ADDENDUM NO. 1

Navajo St. Curb and Sidewalk Improvements (From Salisbury St. to Indian Trail Dr.)

April 4, 2014

CITY OF WEST LAFAYETTE, INDIANA

ALTERNATE #1: RESURFACING PLAN
 BEGIN CONSTRUCTION - STA. 28+00 "A"

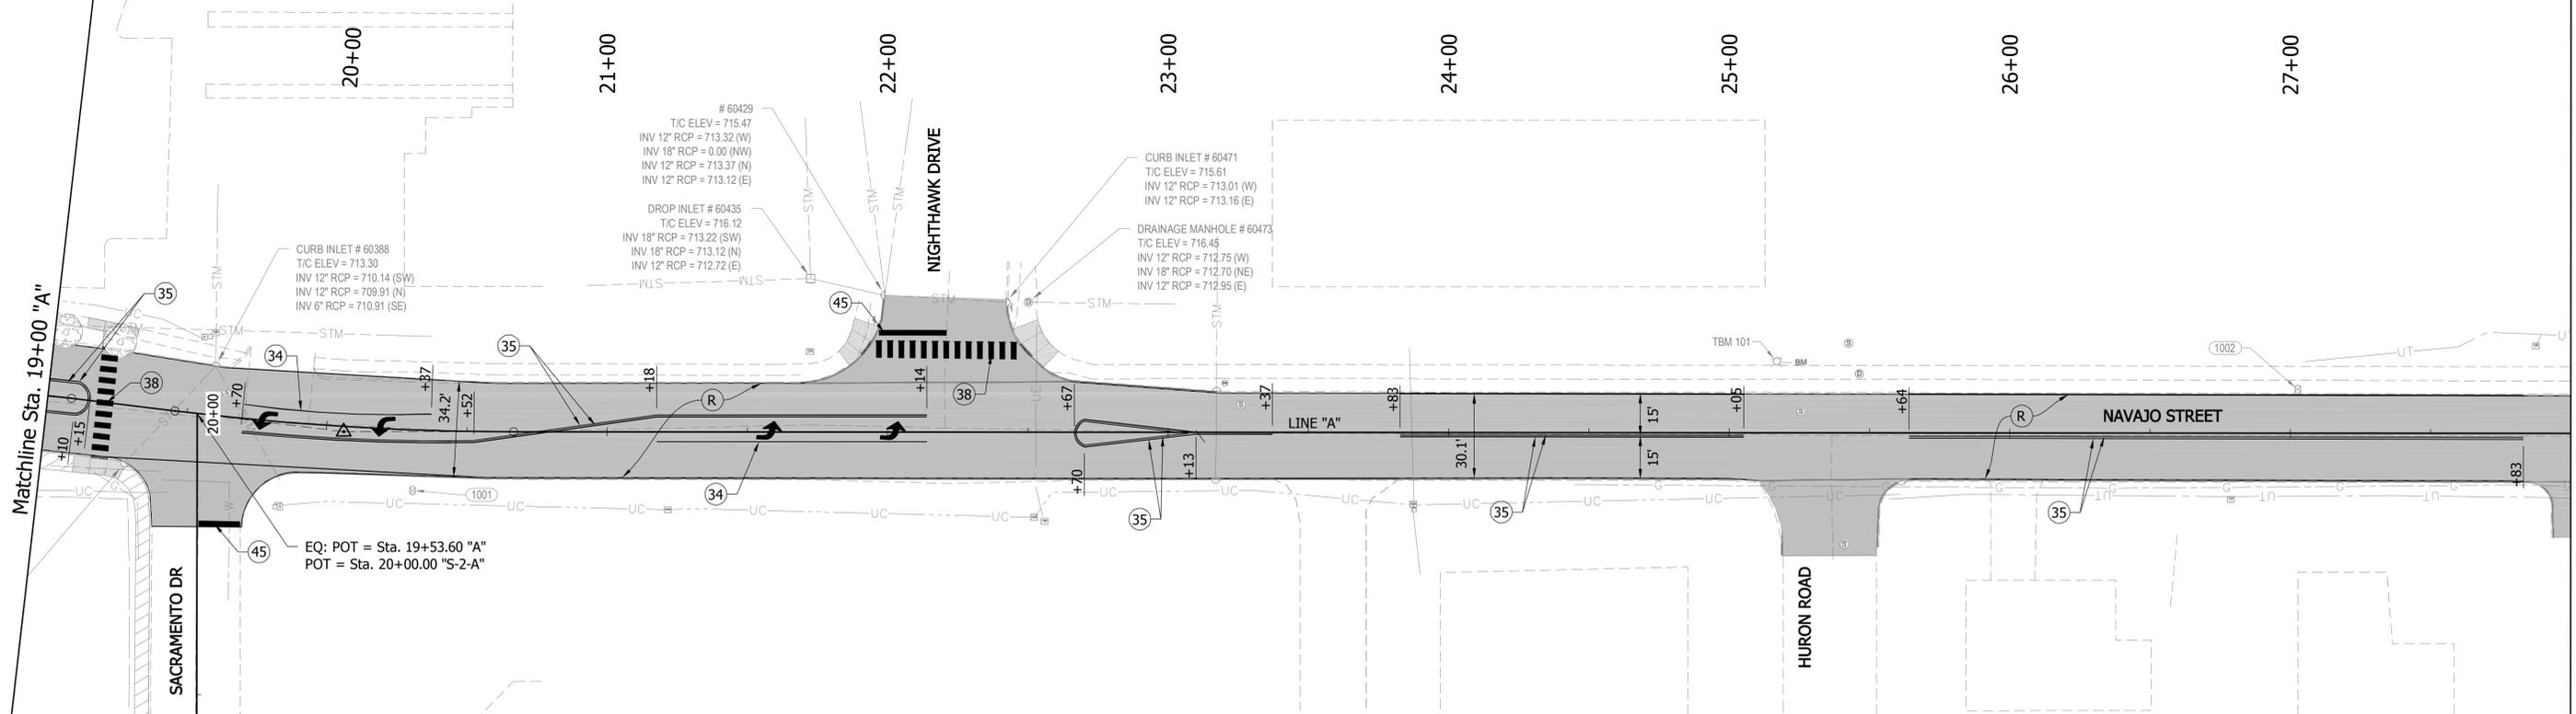
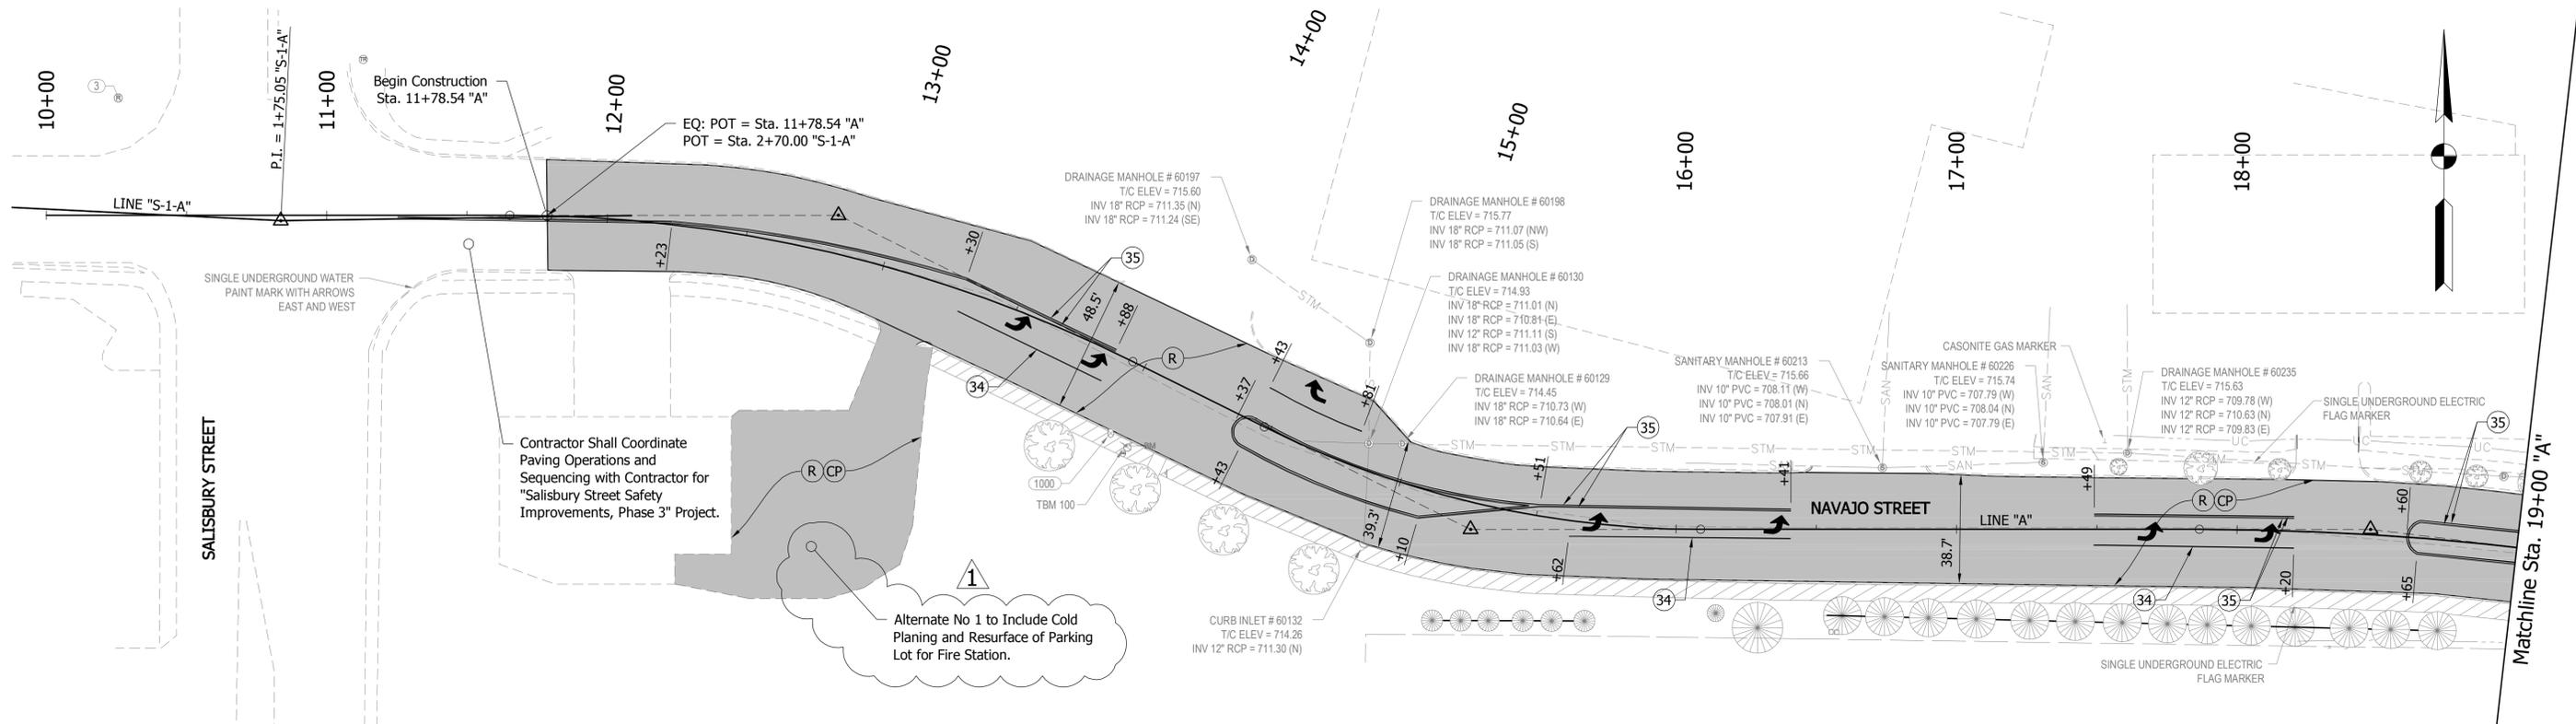
1. Delete Sheet 7 from the construction drawings. Replace with Sheet 7 included in Exhibit C of this Addendum No. 1.

- A. Question: On plan Sheet 7, at the Fire Station, there is reference to milling and paving is in the Navajo Street Resurface. Is that what you are calling Alternate #1?**

Alternate No 1 to Include Cold Planing and Resurface of Parking Lot for Fire Station.

Answer: Cold planing and resurfacing of the Fire Station parking lot is to be included in Alternate #1. Refer to Item No. 1 , D. (located above) for revised Sheet No. 7.
